Errata Sheet MB86296 Coral PA

Errata List:**October 28th, 2005**

Access to host register area fails after video memory is write accessed (only ES sample)

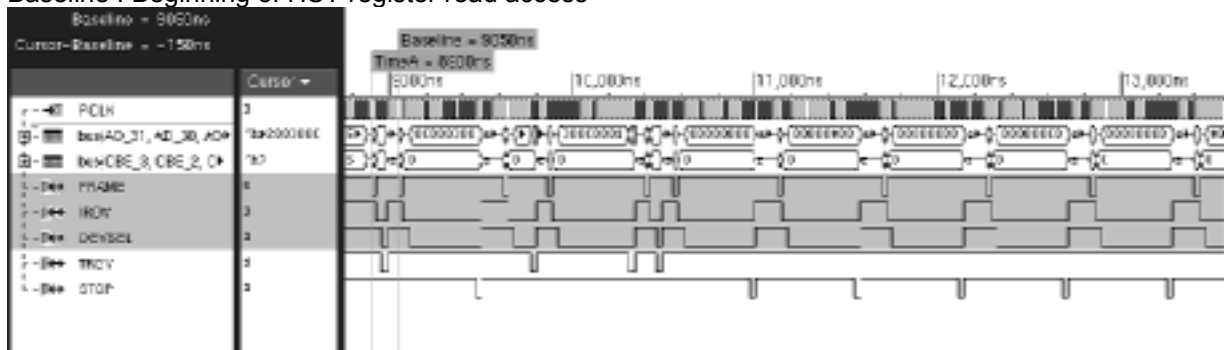
If the CPU accesses the HST register(0x1fc0000-0x1fc00f0) following the VRAM write access as shown in the Figure1, the PCI is hanged up. As the example, while it writes the display list in the VRAM in continuity, the CPU read the IST register by the handler of the interrupt, the the PCI is hanged up.

If the CPU accesses the HST register on the condition that the VRAM write access is waiting internally, the internal state goes wrong.

this problem occurs only with ES-sample, it will be corrected before mass production

Failed data on 1CLOCK or less of the IDLE phase (only ES sample)

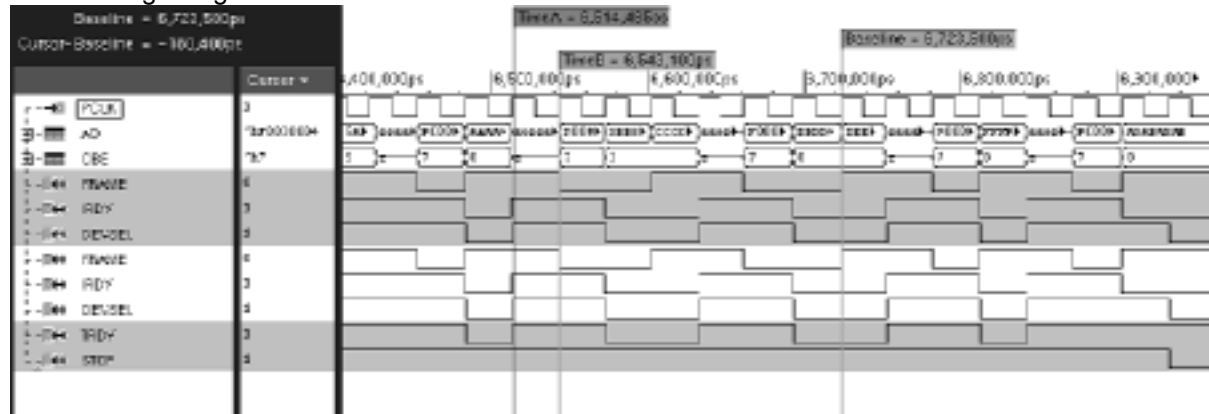
The data is garbled, when the IDLE phase of the write transaction is 1 or less CLOCK cycle (The period between TimeA and TimeB is 1CLOCK cycle as shown the Figure1).

The retrial termination is not performed by asserting the STOP signal by the Baseline clock.

PA : We will modify the logic of PA.

Modifying the logic, Coral-PA will accept 1 clock of the IDLE phase.

But still don't accept 0 clock of the IDLE phase(= This protocol called "fast write to back")

Therefore don't access the Coral-PA in fast write to back protocol.

11-1. Coral = PCI Master.

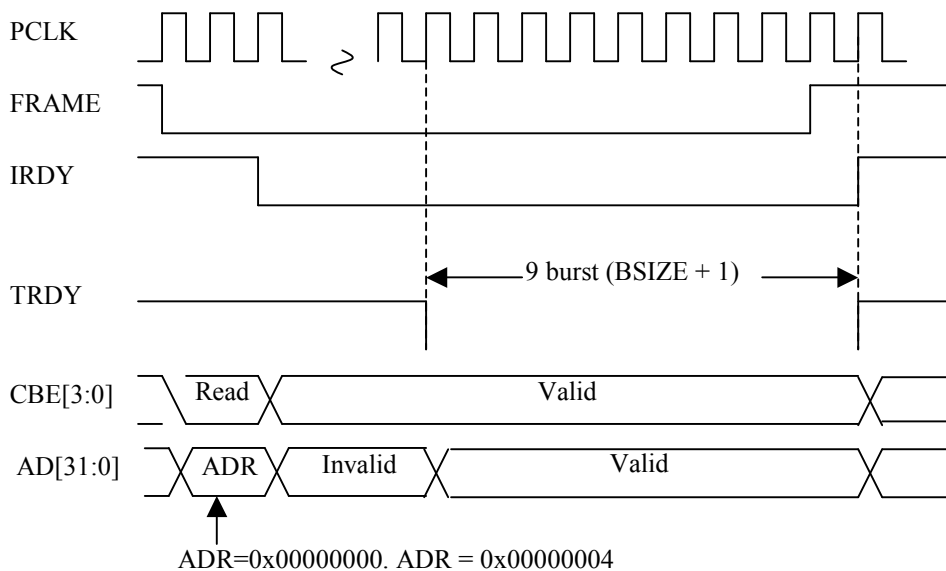
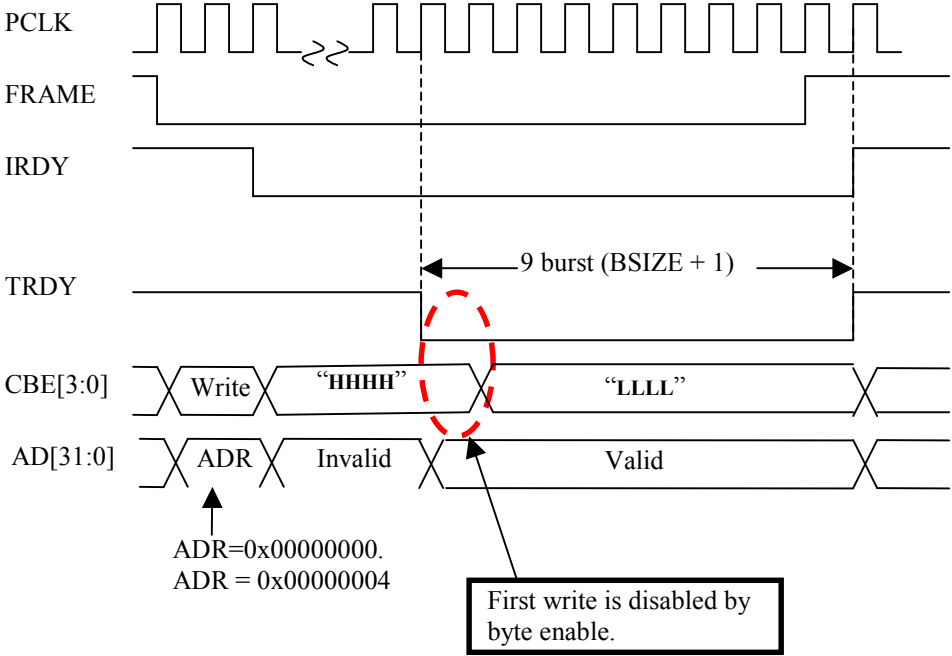
Coral can't issue an odd address to PCI area.

If Coral is the master device and the beginning address is set to the odd address in 64-bit boundary, Coral issue the previous even address.

In Coral master read mode, Coral begins to read the previous even address and read the setting of burst size(BSIZE of BCR) plus "1".

In **Coral master write mode**, Coral begins to write the previous even address with disable write byte enable and write the setting of burst size(BSIZE of BCR) plus "1".

11-2. Coral = PCI Slave.

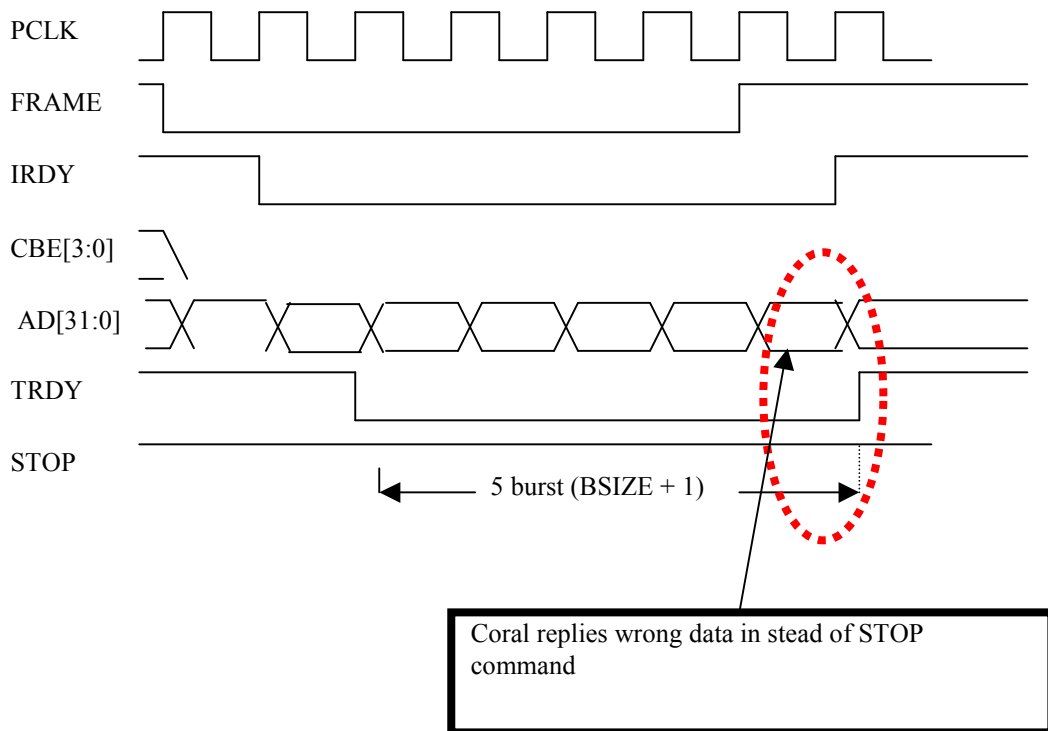
Coral reply the wrong data, if the read burst size comes more than the setting of SRBS.

Coral replies the retry until storing the SRBS size data to Coral's PCI internal buffer.

After stored the data, Coral begins to reply the data by TRDY. But if the burst read comes more than the size of SBRBS, Coral replies the wrong data instead of issuing the STOP.

Figure 1 synchronising the access to the Coral

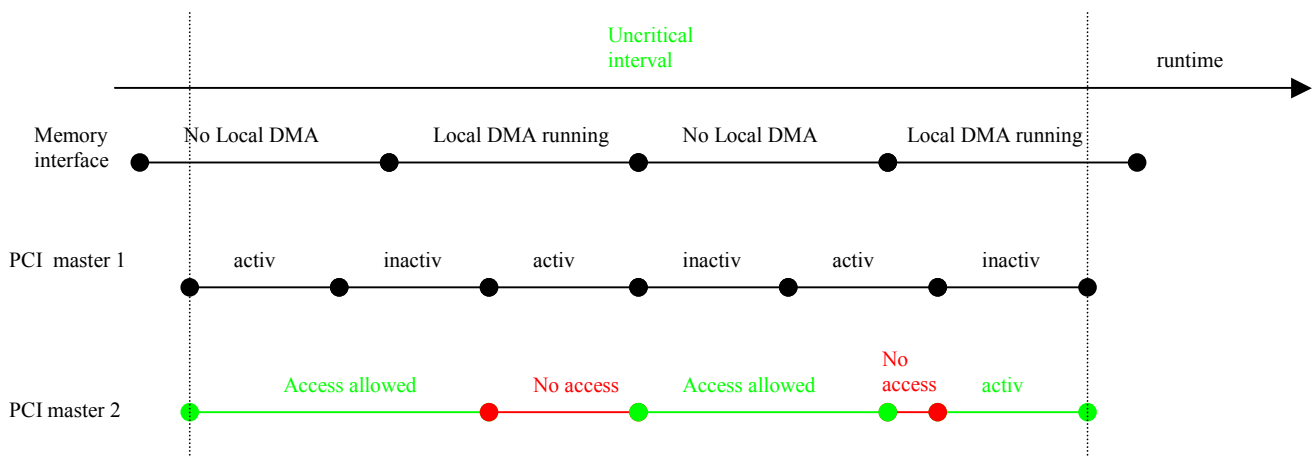
- (1) Two PCI masters access Coral-PA via PCI bus. One master (Master-A) writes data to the memory which connected to Coral-PA. Another master (Master-B) reads data from the Coral-PA. These two transactions are executed independently and simultaneously. The problem does not occur, if both master are reading or writing to the Coral.
- (2) The “Local Display List” transfer and rendering operation are initiated at the same time.

Because of the two independent data transfer from PCI master-A and B, it happens that write transaction from master-A occurs just after RETRY response of PCI from Coral-PA for the preceding read transaction of master-B. In certain condition of internal timing of Coral-PA among above transaction occurring, the write transaction by Master-A fails as the phenomenon that the data is written to different address intended (wrong address is used for the write transaction). In this problem, the wrong address value was swapped from the series of the data originally intended to store the memory. Therefore, the value of the wrong address is random value in general.

The access to the Coral must be synchronised.

Local DMA and multi master access may not occur at the same time. A single master access during a local DMA is running does not evoke the problem.
